Former Landfill Site, Brockhampton West, Harts Farm Way, Havant Highways England Response Note

205465/N04

Vectos Response to HE TA Comments

Appendix B

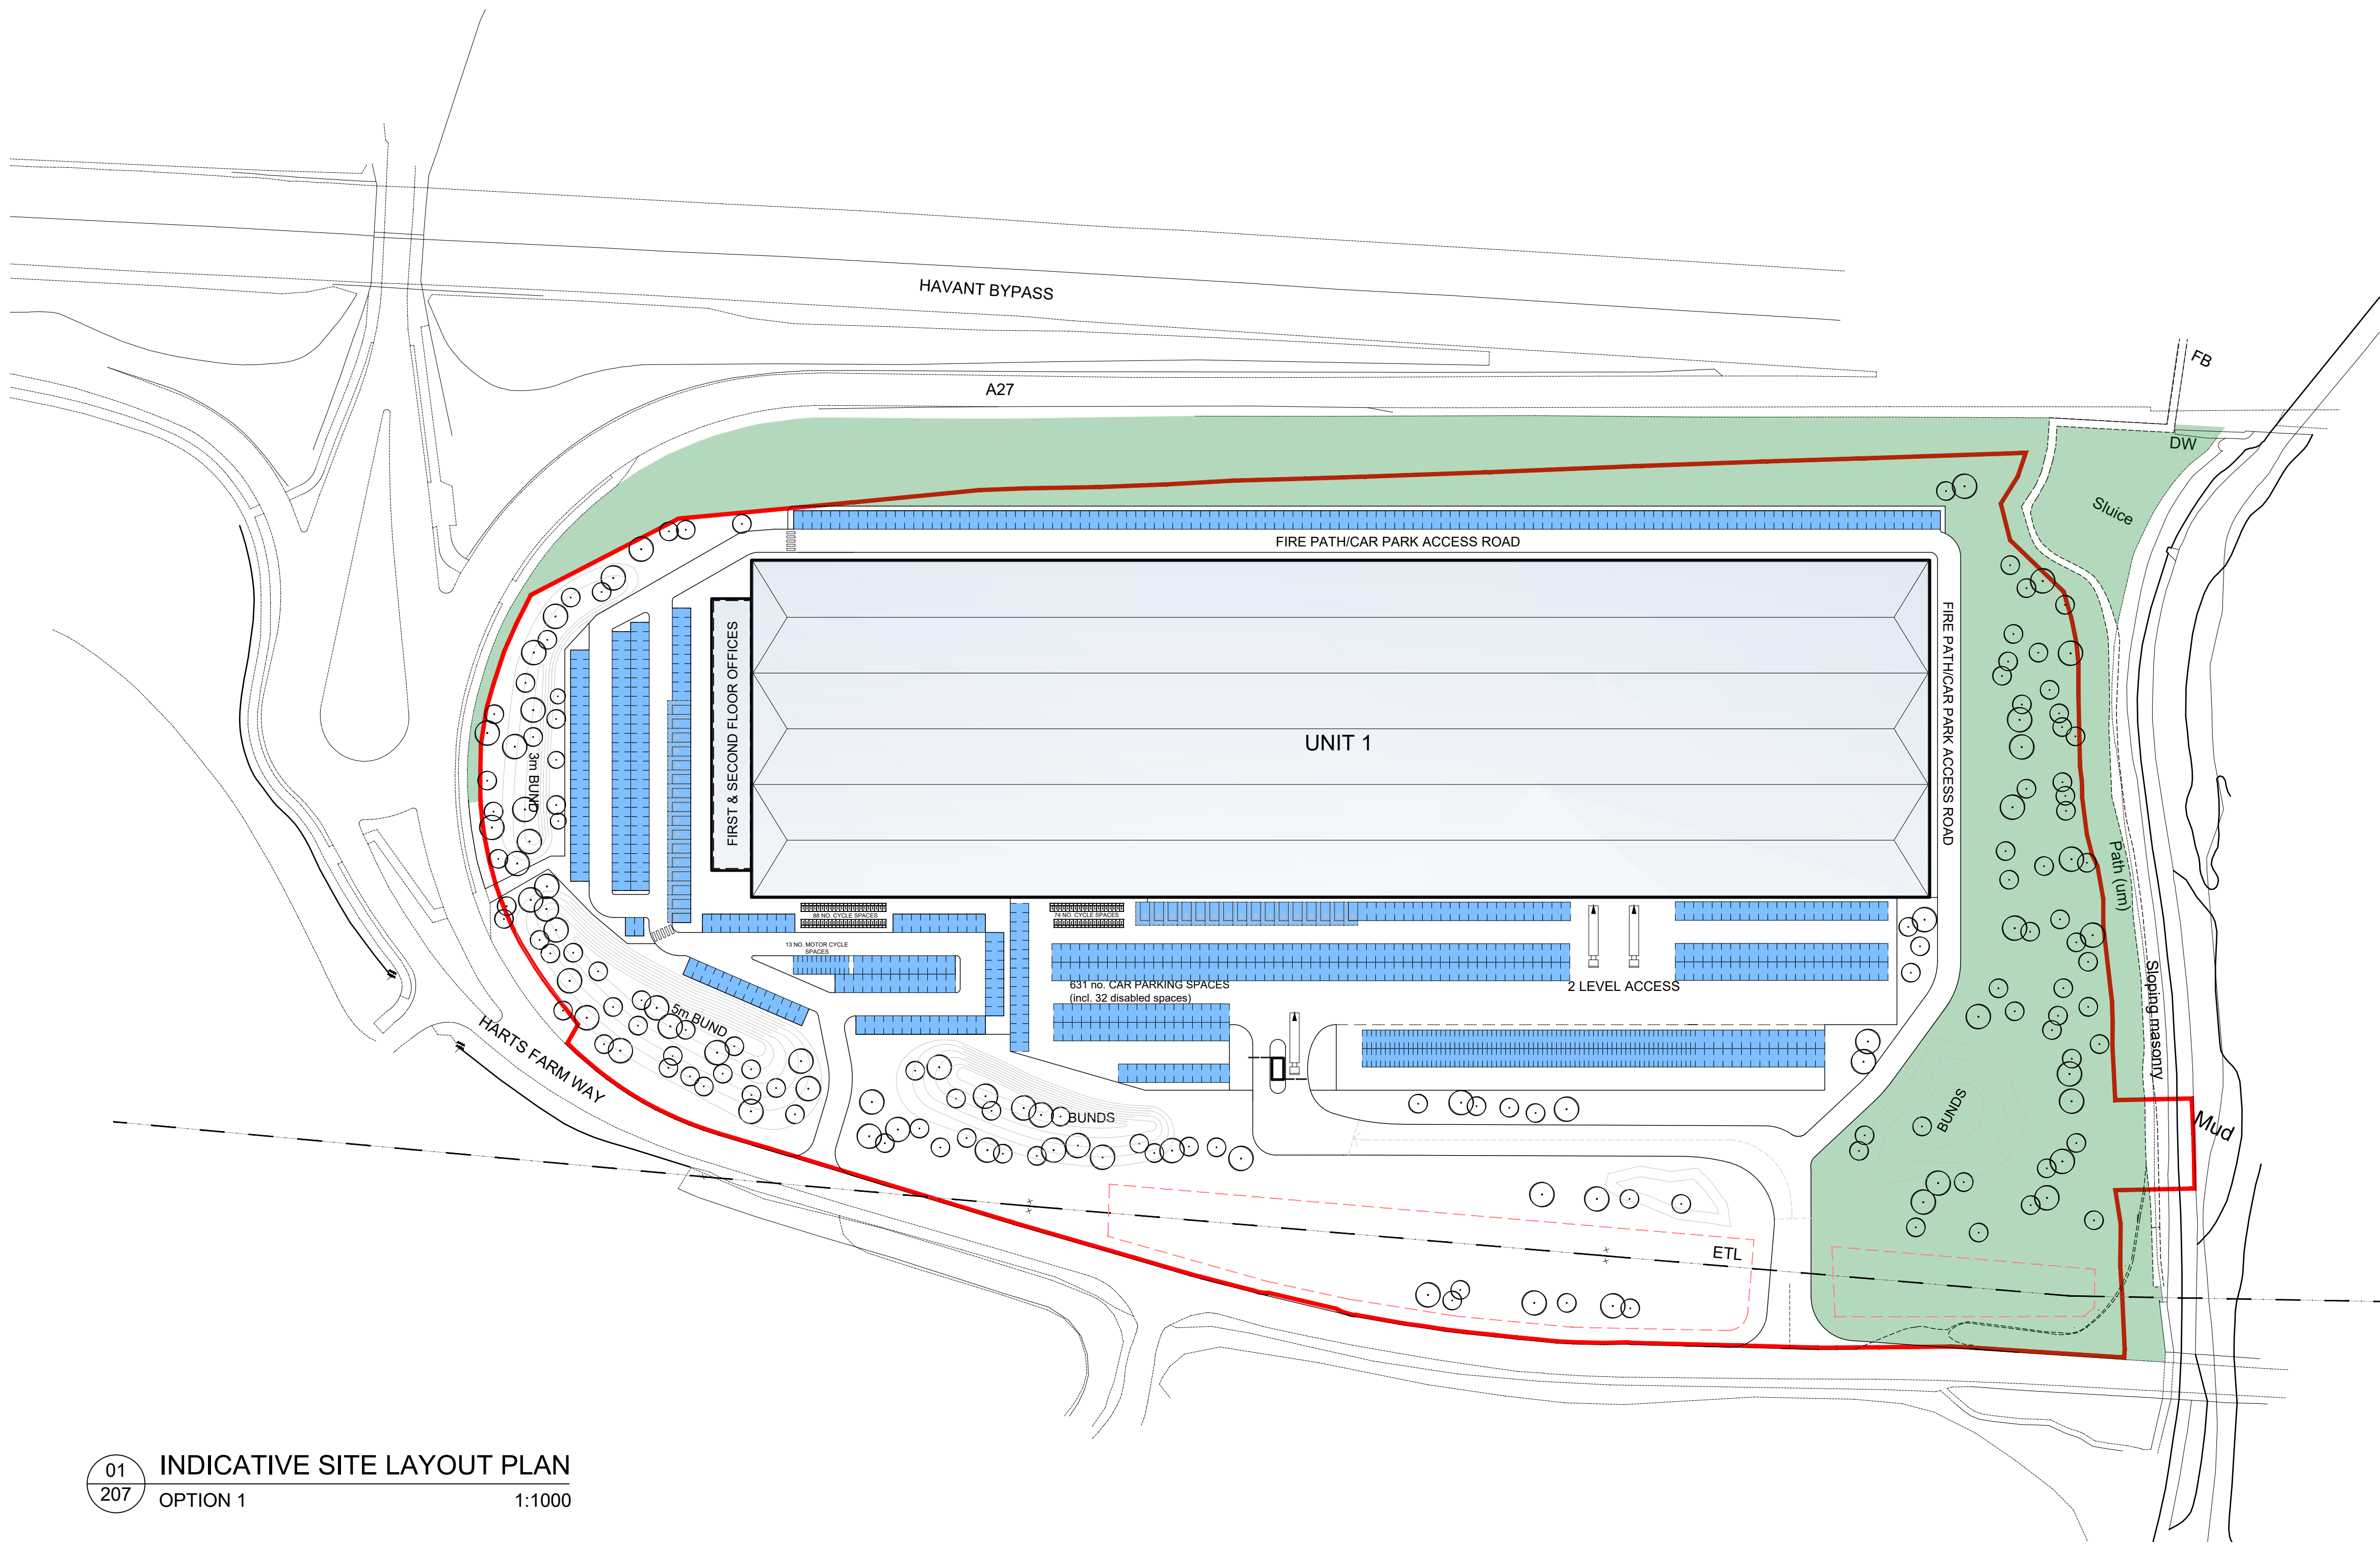
Paragraph 2.47 advises that there are no collision clusters but no plot of the 2015-2020 collision data has been provided to support this view. We request that a plot is provided. If any clusters are identified on the SRN, we request commentary reviewing the collisions.”

7. As requested, a plot of the 2015-2020 collision data has been provided at **Appendix B**. As can be seen, there are no clusters identified on the SRN.

DRAWING NUMBER
31383 / PL / 207

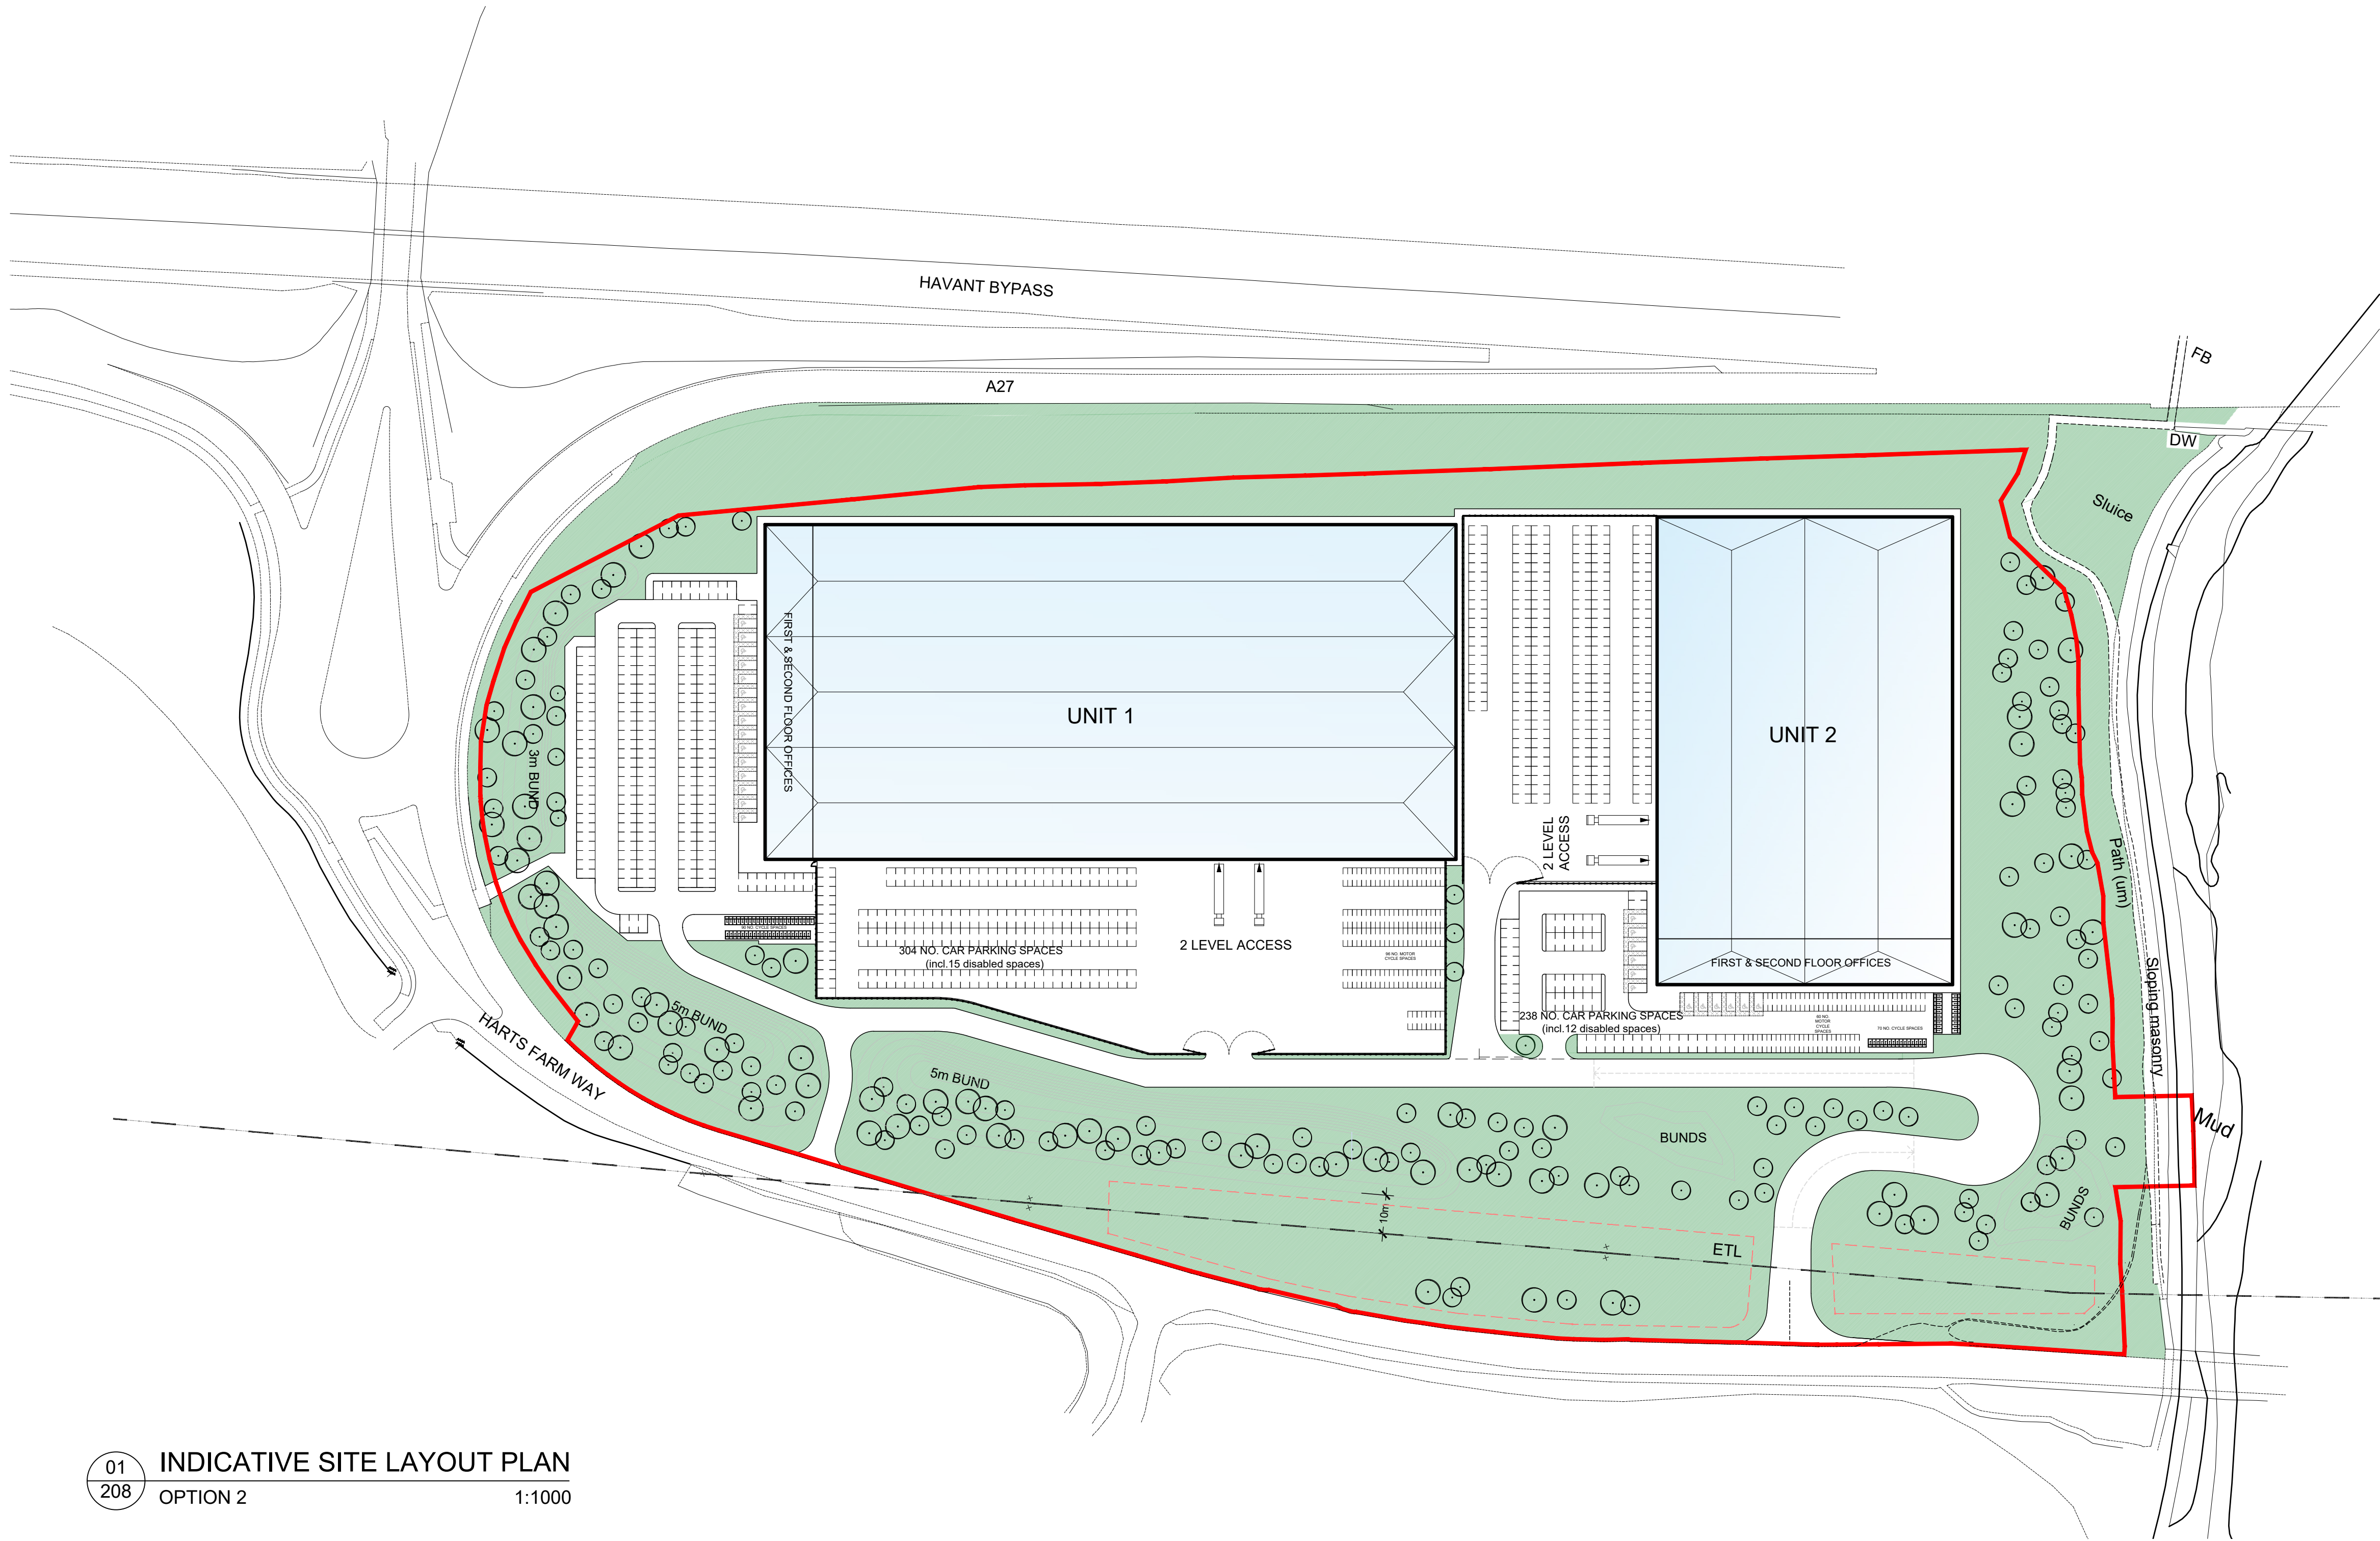
We would expect that a proportional approach to the use classes would be more appropriate as opposed to 100% B8 to ensure that a robust assessment has been undertaken when applying for a mixed-use development. Given the site's close proximity to the SRN A27 westbound off-slip, we would be concerned if there was an under provision of parking that could lead to queuing on Harts Farm Way and onto the A27 mainline. This could lead to capacity and safety impacts on the SRN which would be unacceptable.”

10. For reference site layout plans have been provided with a B2 land use and car parking standards to assess the worst case in terms of car parking which would be a 100% B2 scheme. These updated plans are provided within **Appendix C**. For clarity, the car parking standards, and the required number of spaces per indicative layout is presented in **Table 1**. These standards are taken from Havant Borough Council's Parking SPD (September 2019).

11. As seen at **Appendix C**, the updated plans for the one-unit scheme provide 631 car parking spaces in line with the required standards. The two-unit scheme provides 542 car parking spaces, and although it is acknowledged that this is below the required the minimum standard, we can demonstrate from a car parking accumulation that the demand for car parking from the proposed
